SUBJECT: TECHNICAL SPECIFICATION CHANGES TO ALLOW OPERATION WITH ONE  
RECIRCULATION LOOP AND EXTENDED OPERATING DOMAIN

RE: GRAND GULF NUCLEAR STATION, UNIT 1

The Commission has issued the enclosed Amendment No. 16 to Facility Operating License No. NPF-29 for the Grand Gulf Nuclear Station, Unit 1. This amendment consists of changes to the Technical Specifications (TSs) in response to your application dated March 31, 1986 as amended by letters dated May 2, June 9, and June 20, 1986 and supplemented July 11, 1986.

This amendment changes Technical Specifications to allow plant operation with one recirculation loop operable and to allow operation with increased reactor core cooling water flow rates up to 105% of rated flow rate at reduced power levels and operation with increased reactor power levels at reduced reactor core cooling water flow rates. The amendment does not involve an increase in licensed power level. Technical Specification changes include elimination of the average power range monitor trip setpoint and changes to allow rated power operation with feedwater temperatures reduced 50°F below rated feedwater temperature (420°F).

FIGURE 3.2.1-1 MAXIMUM AVERAGE PLANAR LINEAR HEAT GENERATION RATE (MAPLHGR) VERSUS AVERAGE PLANAR EXPOSURE FOR TWO LOOP OPERATION INITIAL CORE FUEL TYPES 8CR210, 8CR160 and 8CR071

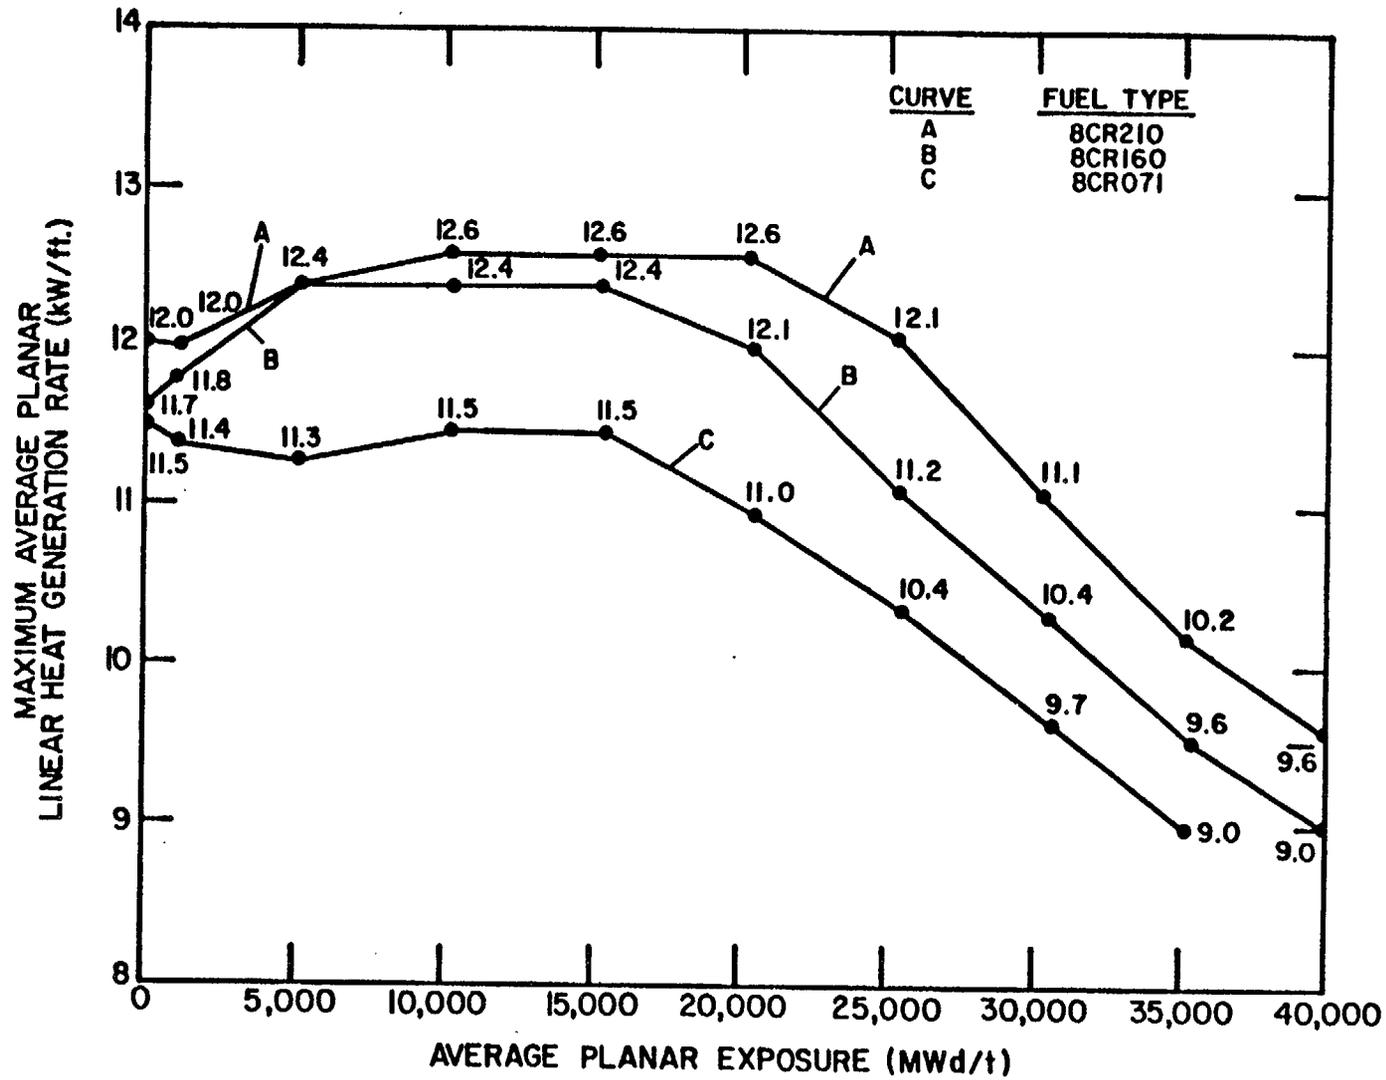
- (2) Specification 3/4.2.1. The proposed change to this specification dealing with MAPLHGR limits results from the proposed elimination of APRM setdown in Specification 3/4.2.2. The current specifications provide for reduction in the flow-biased APRM trips when the core maximum total peaking factor exceeds the design total peaking factor. With the proposed elimination of APRM setdown, this peaking effect is covered by revision to the MAPLHGR limits. The revised limits are presented as graphs for both a flow dependent and power dependent MAPLHGR factor in Figures 3.2.1-2 and 3.2.1-3. As discussed in reference 2, the revised limits provide equal or increased margins to fuel integrity limits relative to those obtained with APRM setdown. We find the proposed changes acceptable.

FIGURE 3.2.1-2 MAPFAC<sub>f</sub>

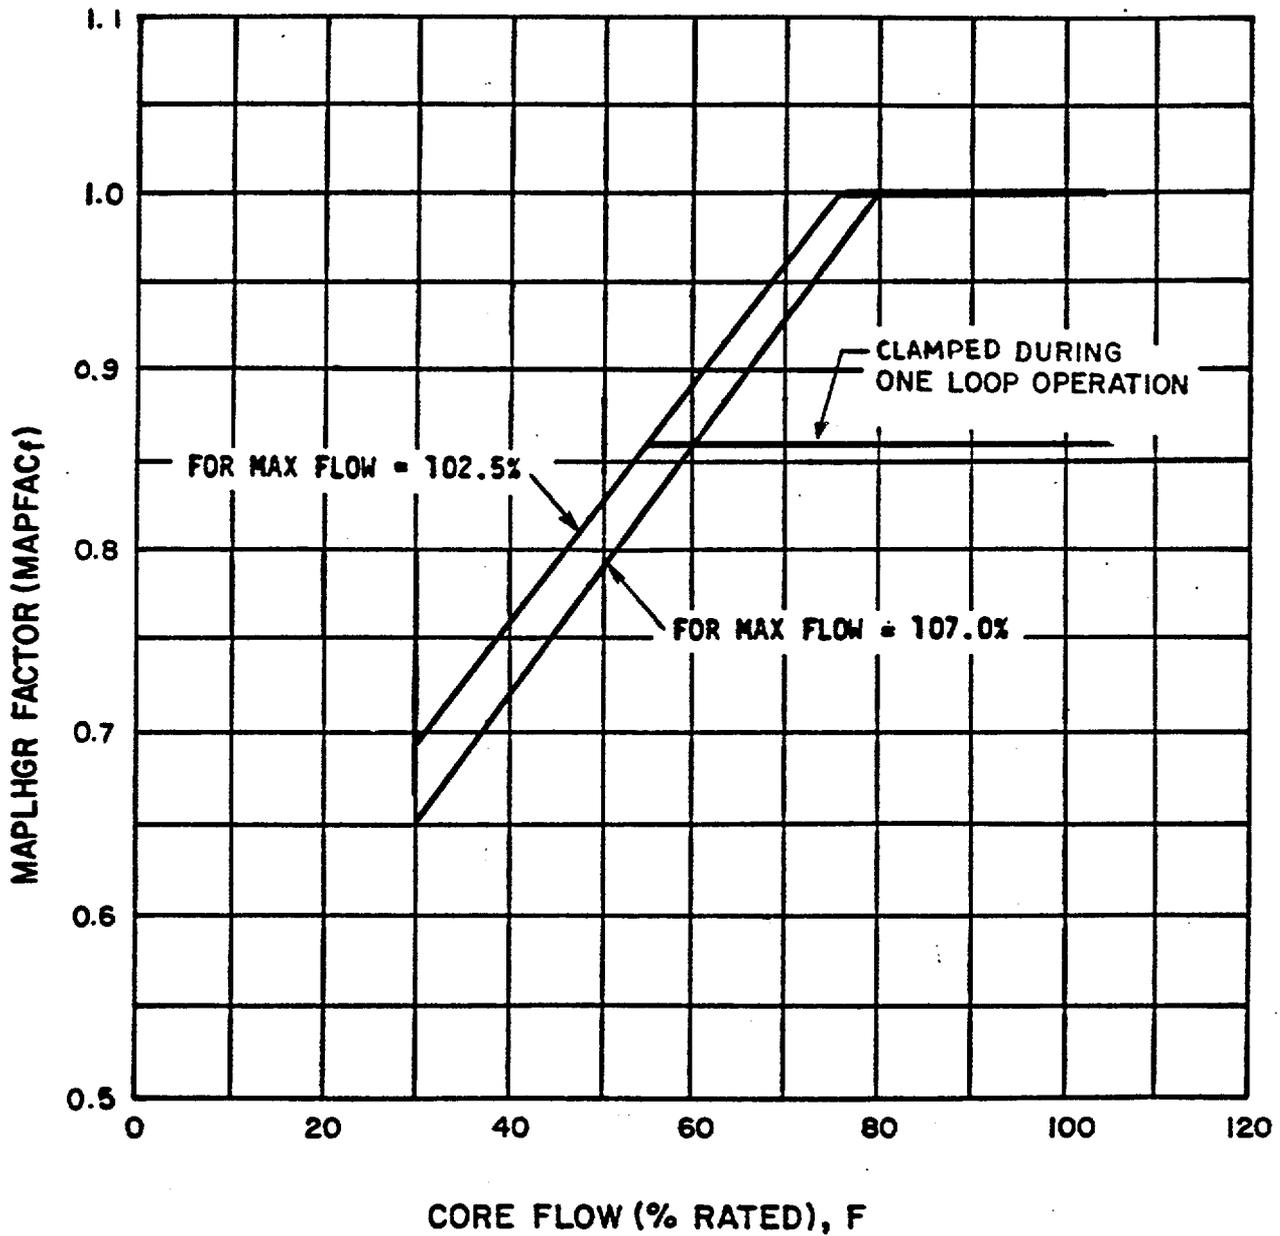
(4) Specification 3/4.2.1. MAPLHGR will be multiplied by the smaller of either the flow-dependent MAPLHGR factor ( $MAPFAC_f$ ) of Figure 3.2.1-2, or the power dependent MAPLHGR factor ( $MAPFAC_p$ ) of Figure 3.2.1-3. This is acceptable.

FIGURE 3.2.3-1 MCPR<sub>f</sub>

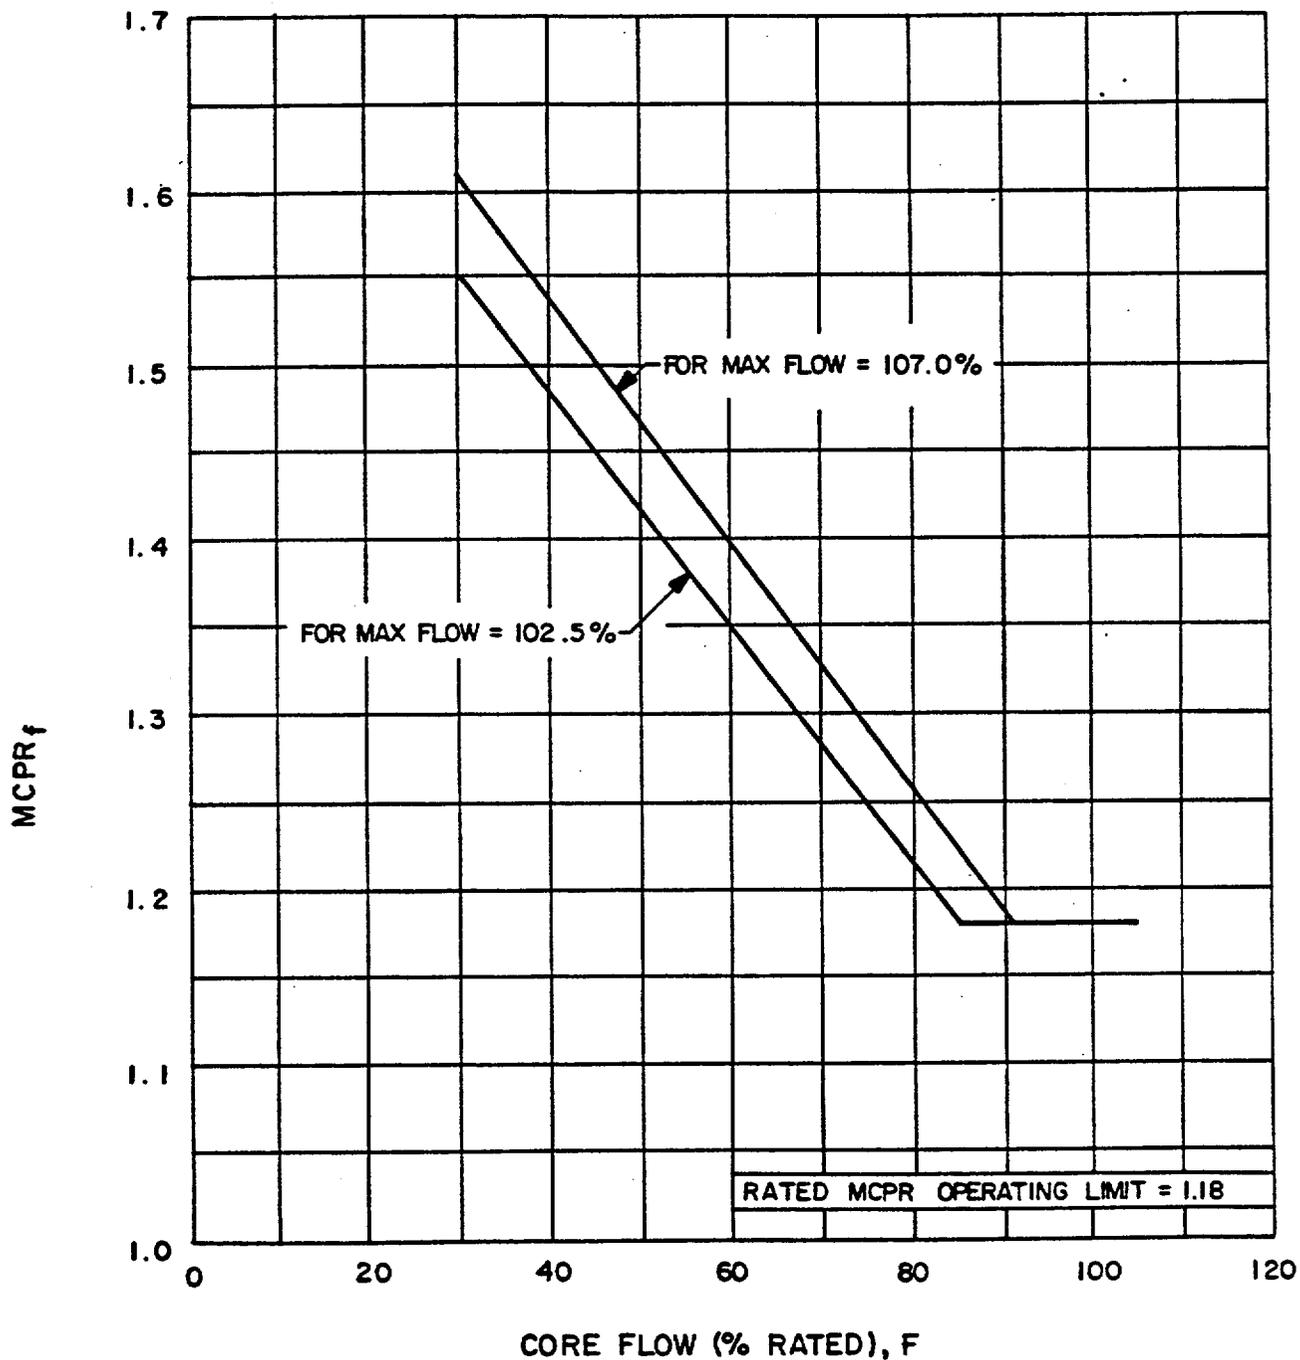
results in new flow dependent MCPR limit curves. The new curves, shown in Figure 3.2.3-1, are slightly above the curve in the current Technical Specifications. The new set of power dependent MCPR limits shown in Figure 3.2.3-2 result from elimination of APRM setdown. The new limits include the effect of operation at feedwater temperature reductions up to 50° F. The operating limit MCPR at any power/flow condition is the larger of the new flow and power dependent values. We find the proposed changes acceptable.

FIGURE 3.4.1.1-1 POWER-FLOW OPERATING MAP

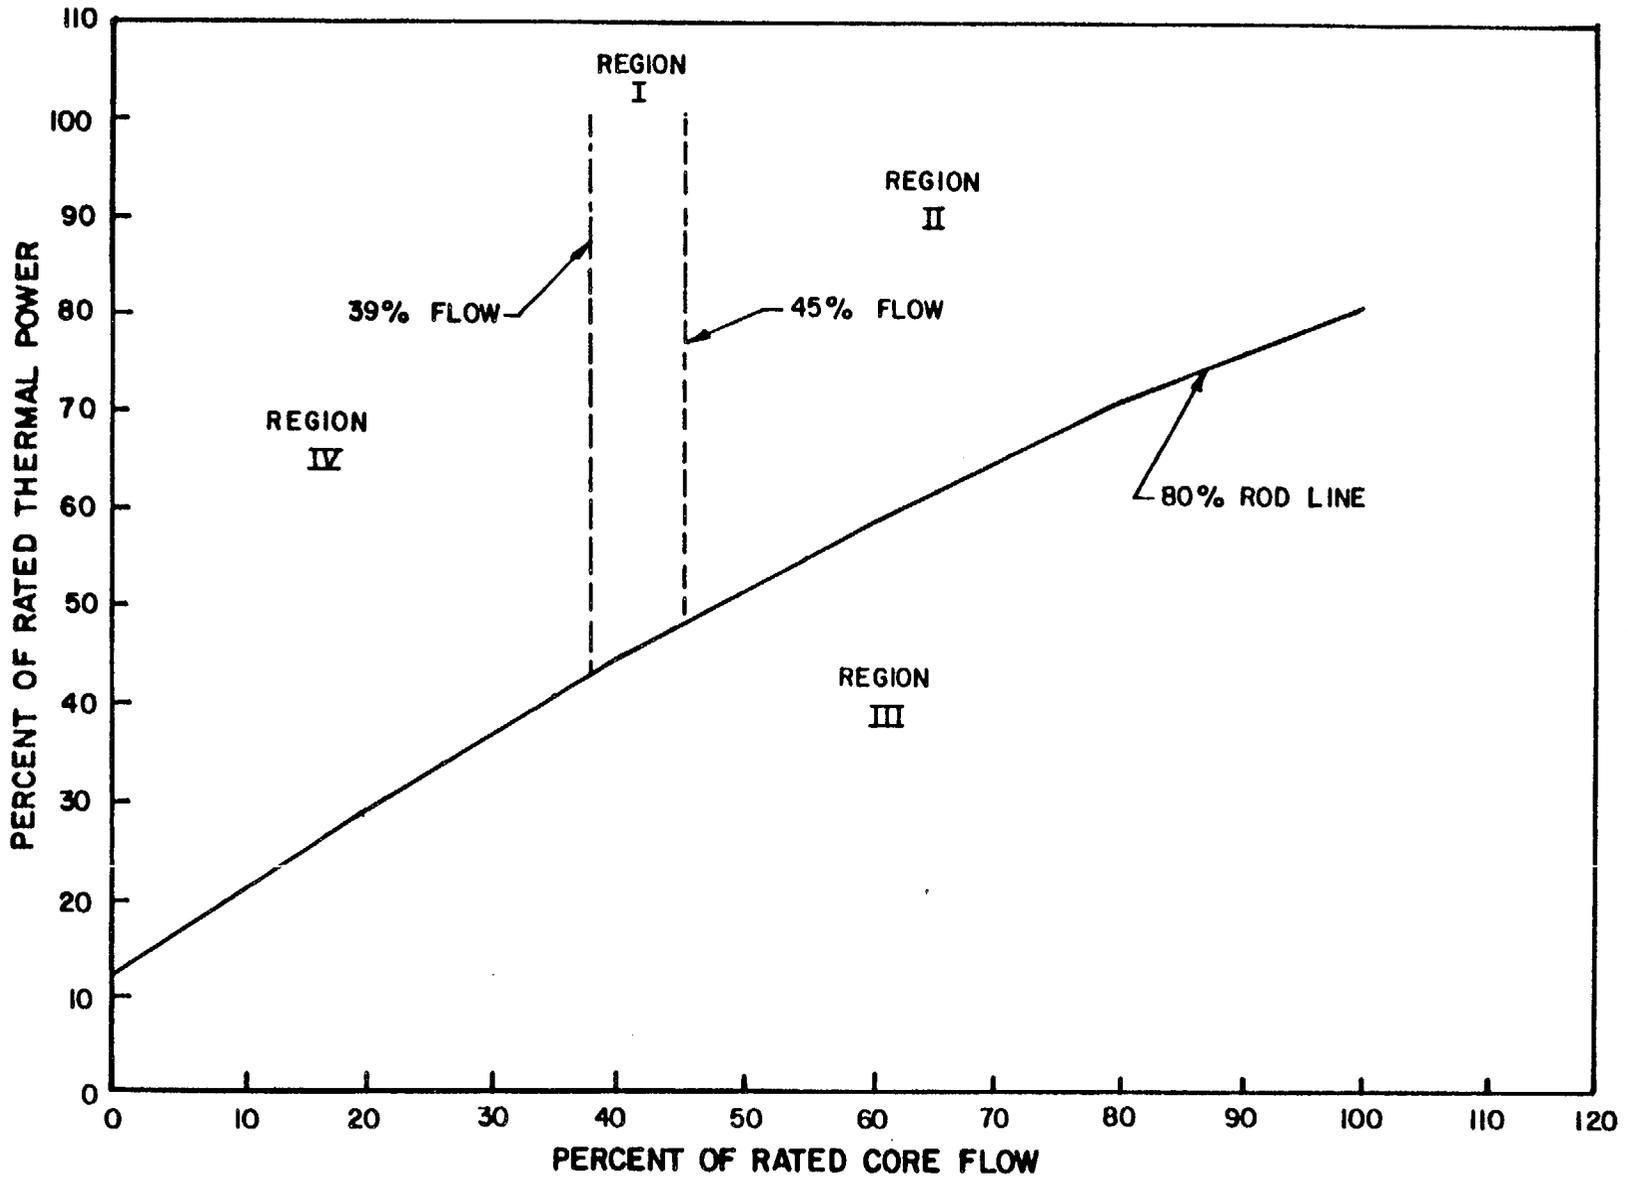
(7) Specification 3/4.4.1. This section is modified to permit operation with either one or two loops in operation. The LCO is expanded to address operation while one recirculation loop is out of service. This change is based on and justified by the GE analysis of SLO and is acceptable.
